Product Change Notification

Product Change Notification: PCN-22-127637

2.5MM PIN HOUSING, 2-4 POSITION ASSEMBLY

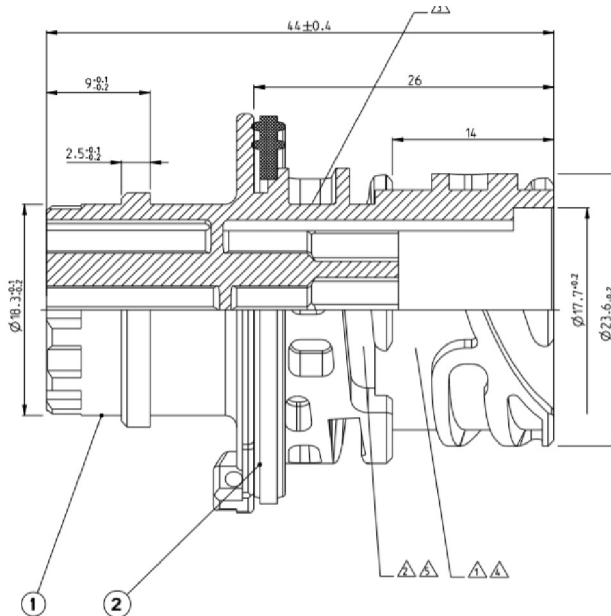
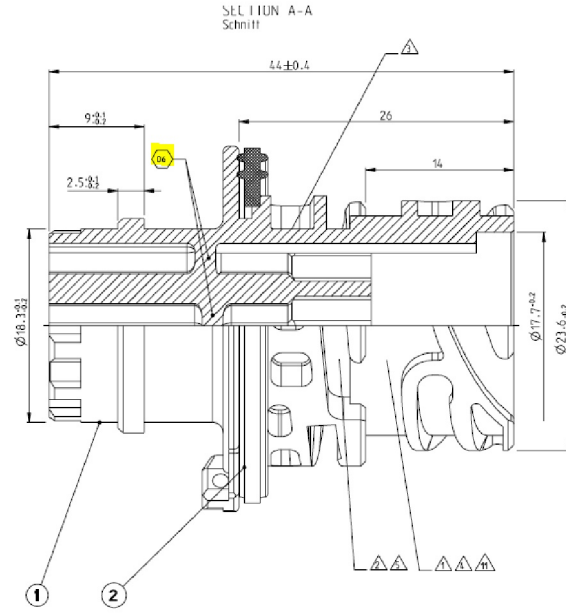
The Industrial and Commercial Transportation business unit of TE Connectivity is making a drawing change to the ordering information and the wall thickness within housing cores for the product drawing(s) listed below. REASON FOR CHANGES: Dear Customer, we hereby inform you of this drawing change. The change is necessary to clarify part marking and ordering information and show the additional wall thickness stated in PCN-21-124260. The change does not impact performance. IMPORTANT: The current and previous revisions of these parts can be used interchangeably in the field. The change(s) are being phased in gradually and previous revision can remain stocked until use. Shipments of both configurations may be mixed.
